UNITED STATES
DEPARTMENT OF THE INTERIOR
BUREAU OF LAND MANAGEMENTFORM APPROVED
OMB NO. 1004-0135
Expires: July 31, 2010**SUNDRY NOTICES AND REPORTS ON WELLS**
*Do not use this form for proposals to drill or to re-enter an abandoned well. Use form 3160-3 (APD) for such proposals.*5. Lease Serial No.
NMNM78213

SUBMIT IN TRIPLICATE - Other instructions on reverse side.8. Well Name and No.
WALT CANYON AMA FEDERAL 99. API Well No.
30-015-3246810. Field and Pool, or Exploratory
INDIAN BASIN; UP ASSOC

Yates Petroleum Corporation plans to Plug and Abandon this well as follows:

WELL NAME: Walt Canyon AMA Fed # 9

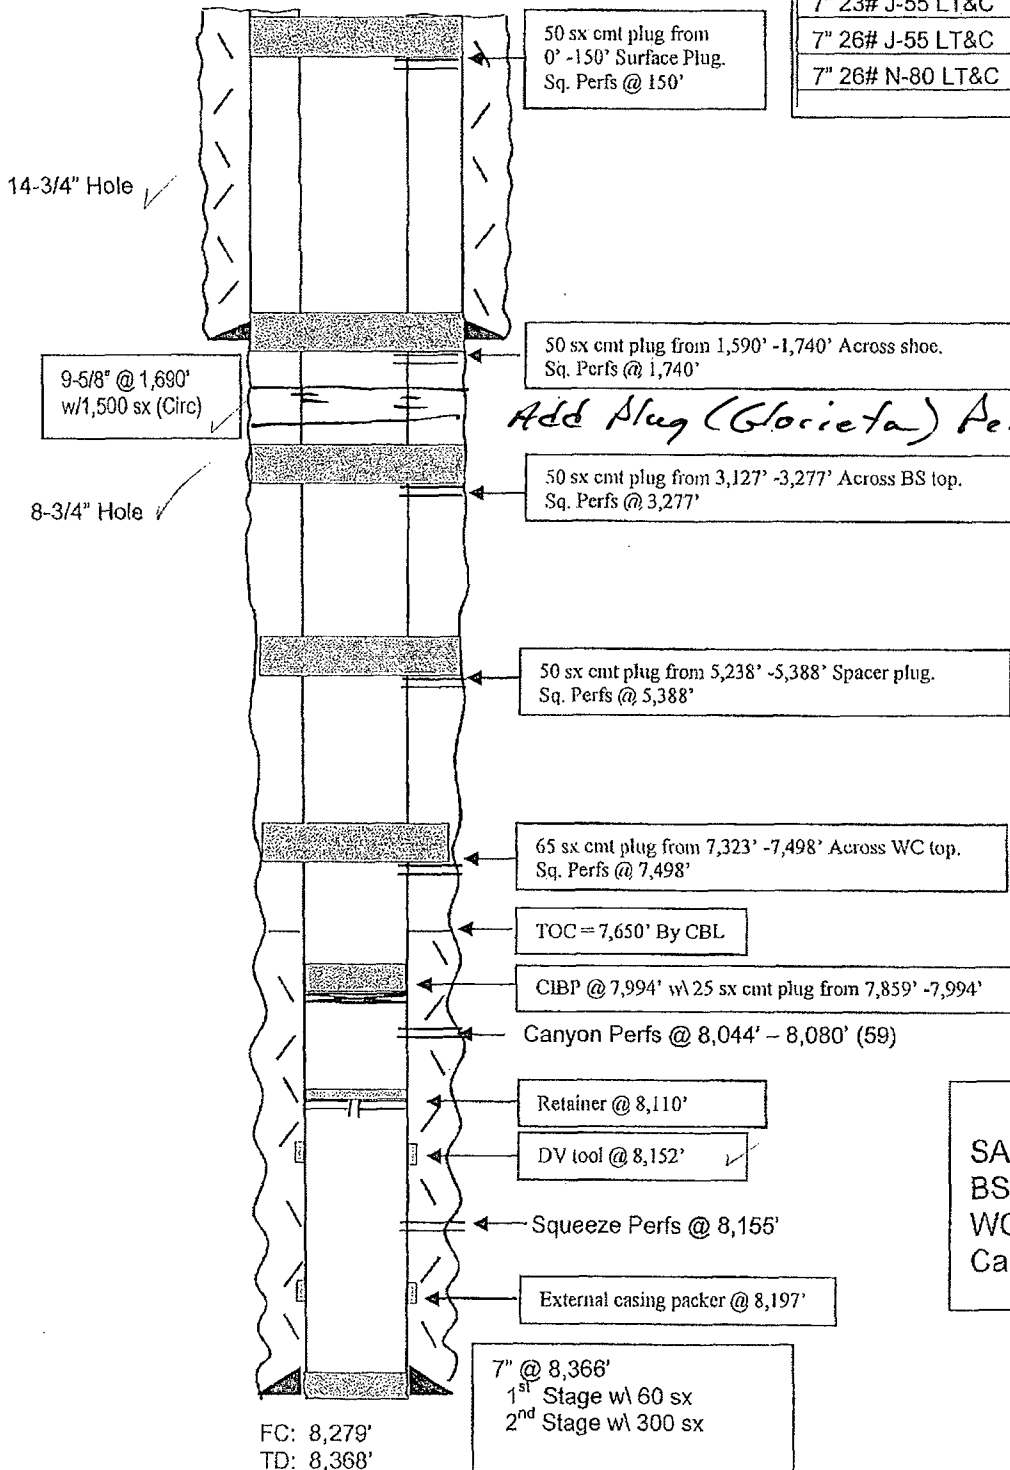
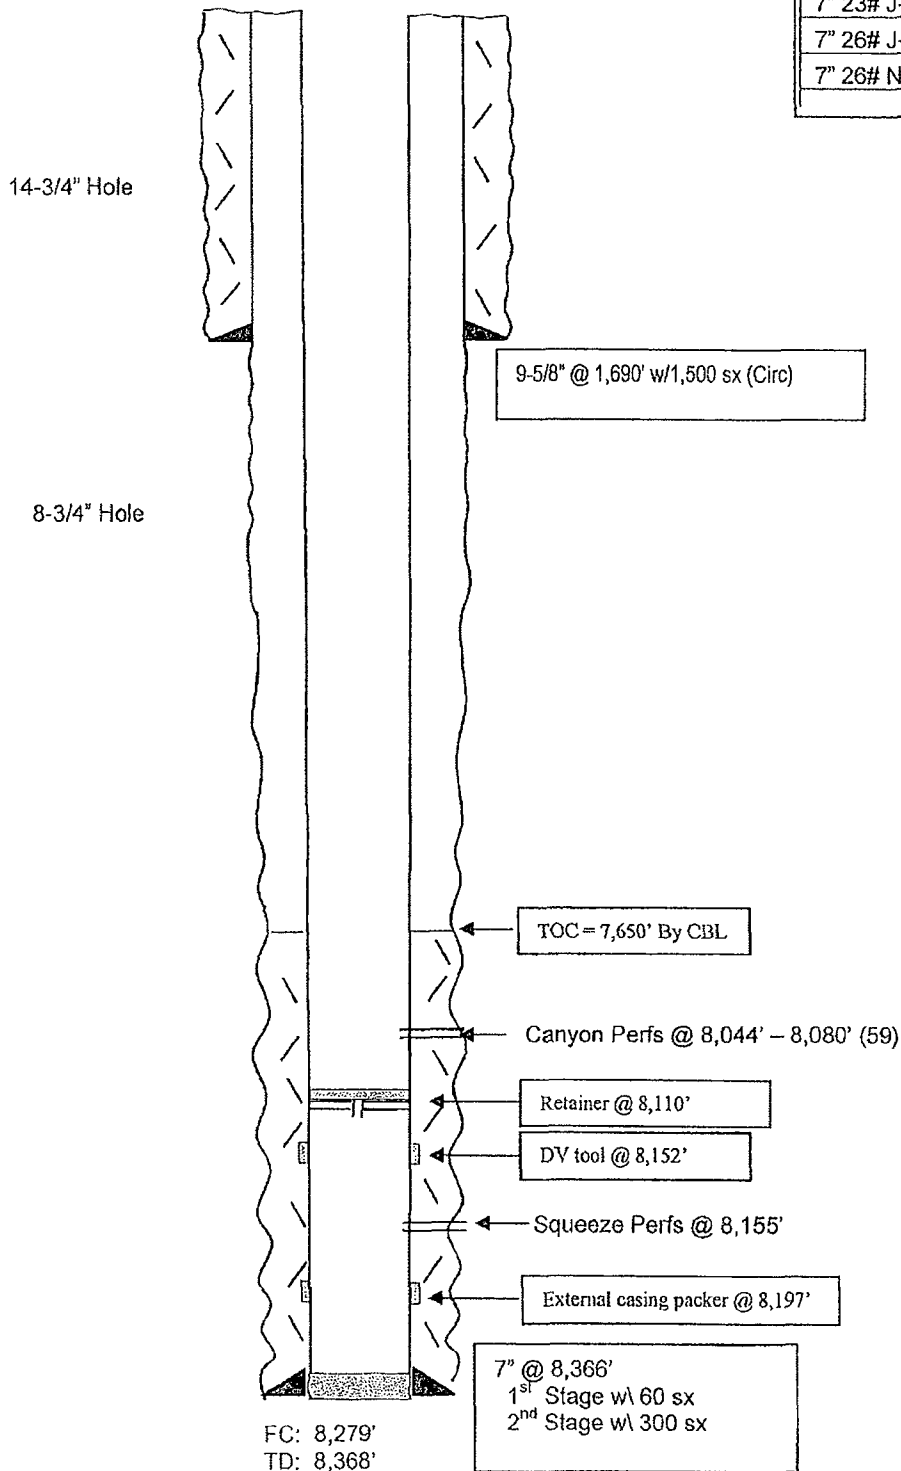
*Add Plug (Glorieta)
Perf 2890.5Q2 Cn
To 2770. WOC Tag*

Add Plug (Glorieta) Perft 2890, SQZ Cost to 2770 WOC Tag
